January 15, 2019
Subject: Mays Bridge Replacement
State WIN: 021697.00
Location: Lubec
Amendment No. 1

Please make the following changes to the Bid Documents:

REMOVE sheet	and REPLACE with sheet
2	2A
15	15A
16	16A

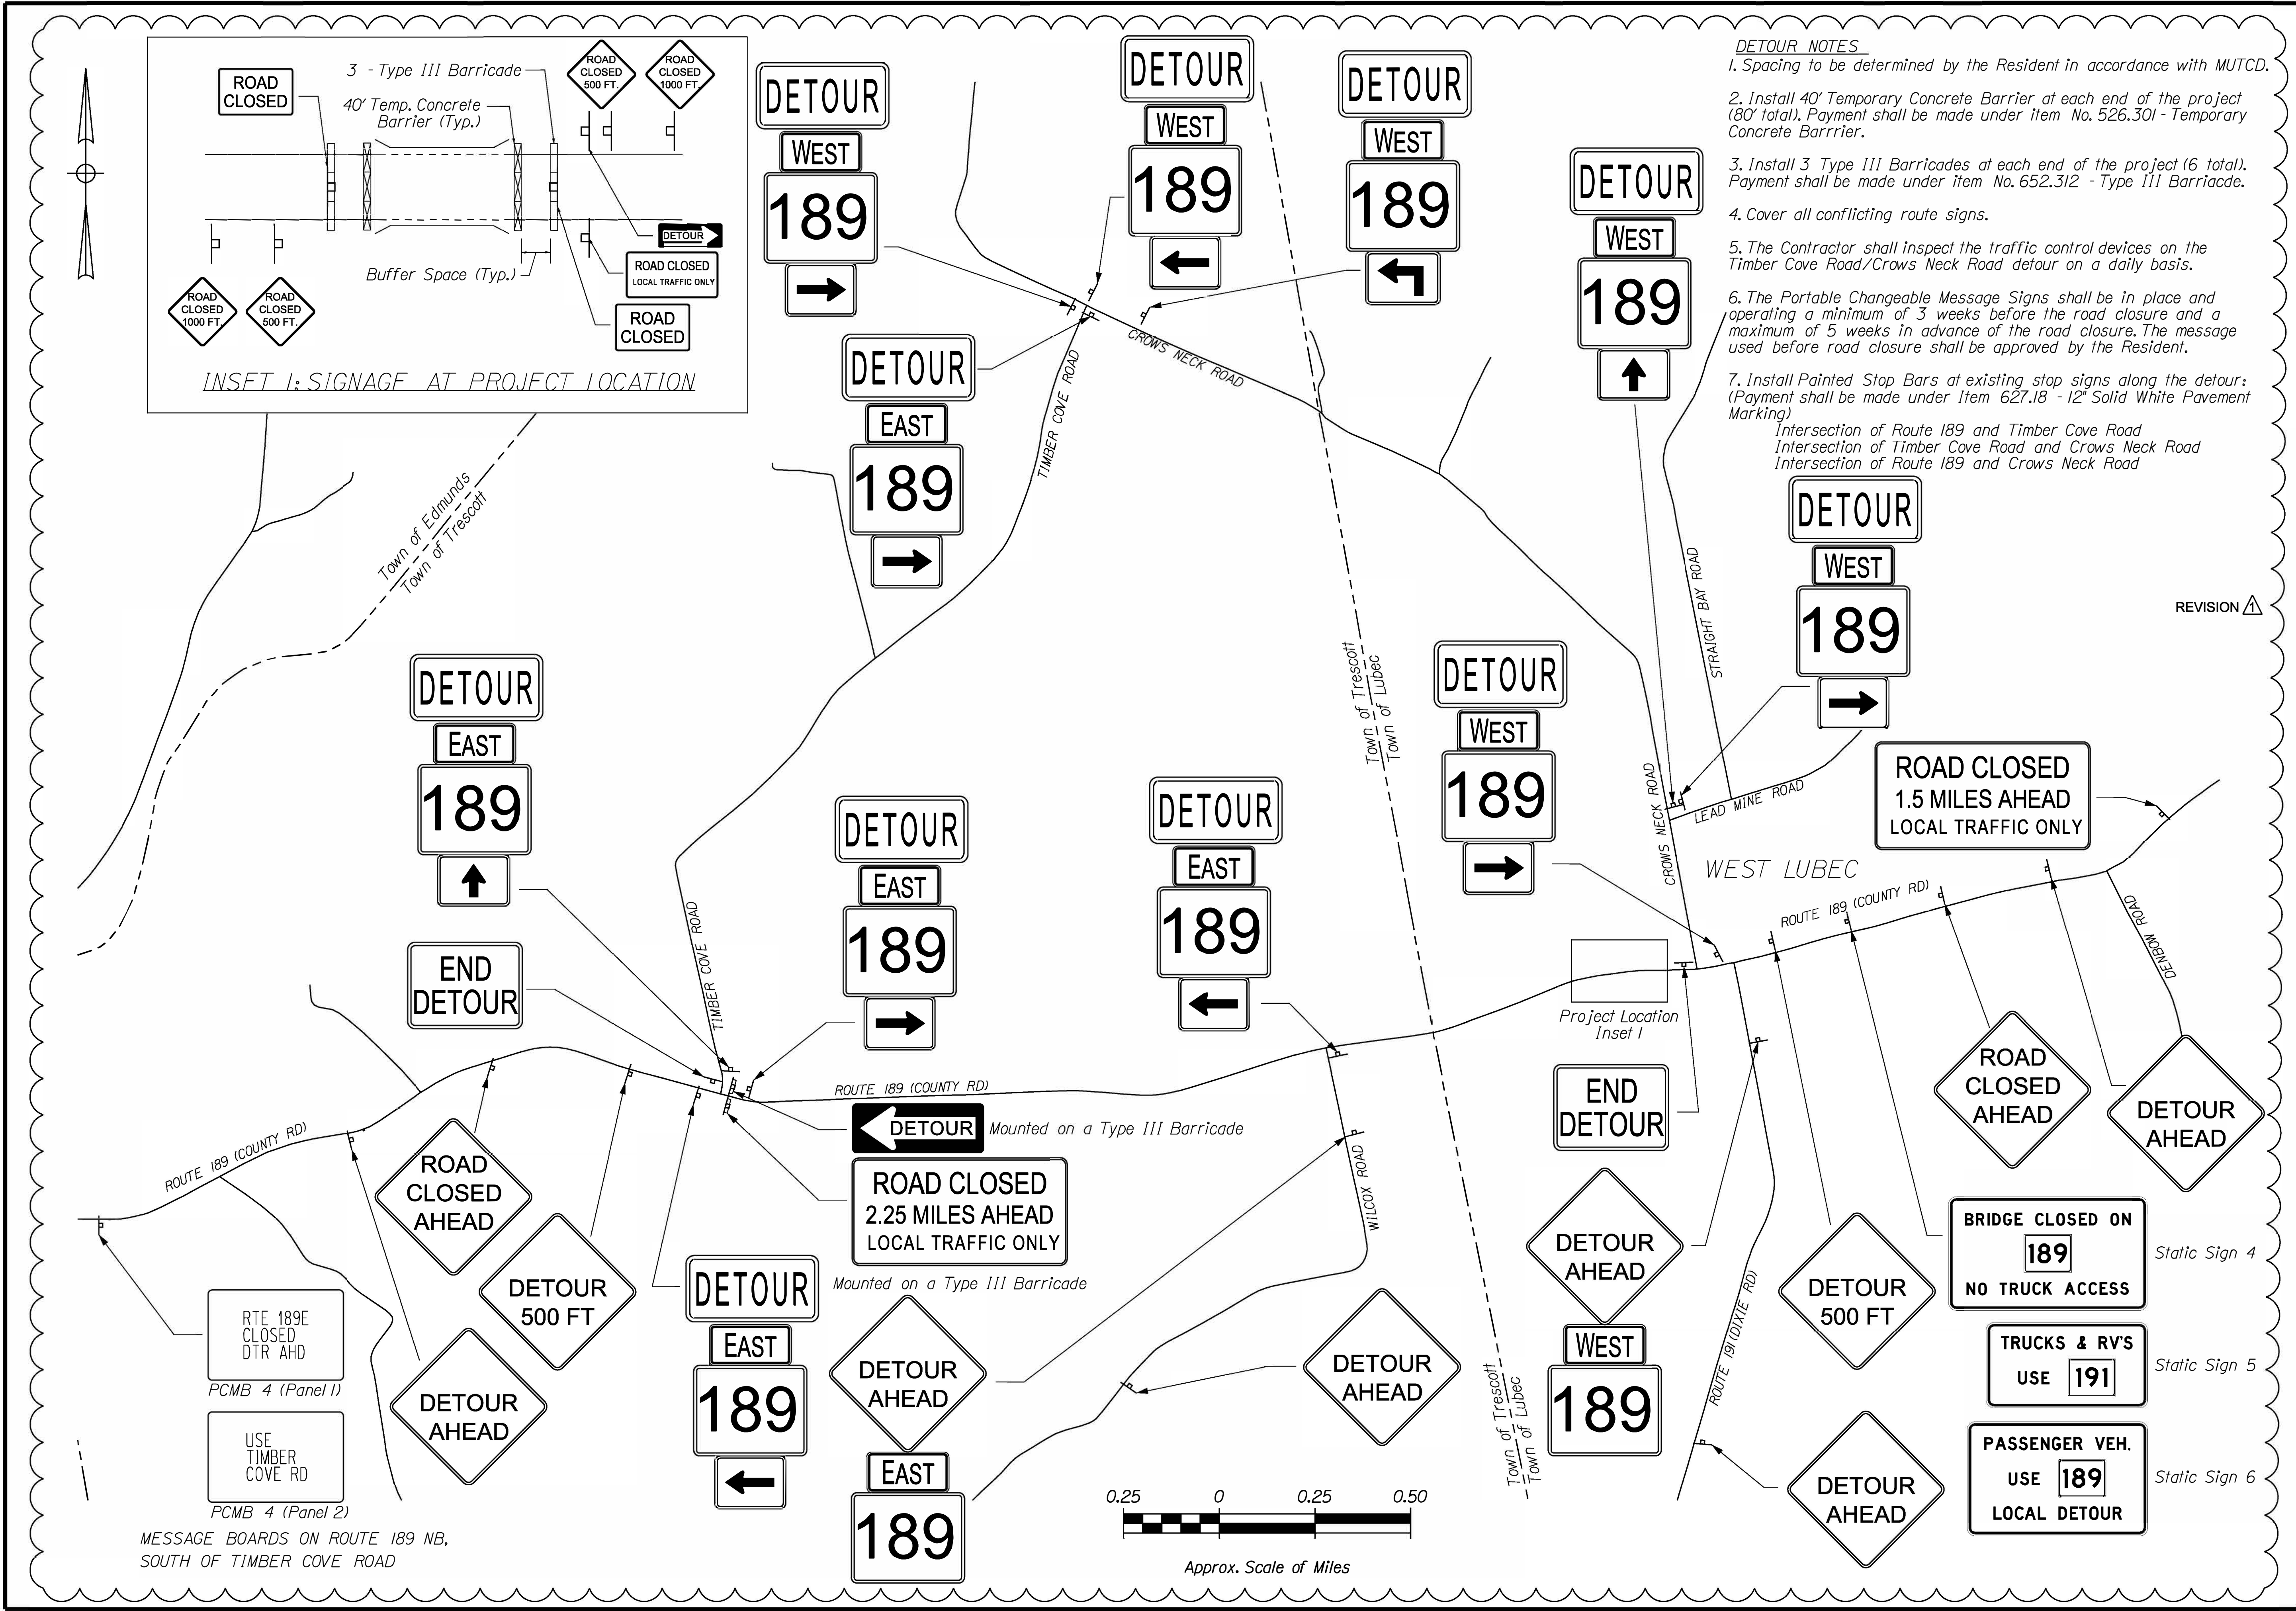
- DETOUR NOTES**
1. Spacing to be determined by the Resident in accordance with MUTCD.
 2. Install 40' Temporary Concrete Barrier at each end of the project (80' total). Payment shall be made under item No. 526.301 - Temporary Concrete Barrier.

3. Install 3 Type III Barricades at each end of the project (6 total). Payment shall be made under item No. 652.312 - Type III Barriacde.
 4. Cover all conflicting route signs.

5. The Contractor shall inspect the traffic control devices on the Timber Cove Road/Crows Neck Road detour on a daily basis.
 6. The Portable Changeable Message Signs shall be in place and operating a minimum of 3 weeks before the road closure and a maximum of 5 weeks in advance of the road closure. The message used before road closure shall be approved by the Resident.

7. Install Painted Stop Bars at existing stop signs along the detour: (Payment shall be made under Item 627.18 - 12" Solid White Pavement Marking)
- Intersection of Route 189 and Timber Cove Road
Intersection of Timber Cove Road and Crows Neck Road
Intersection of Route 189 and Crows Neck Road
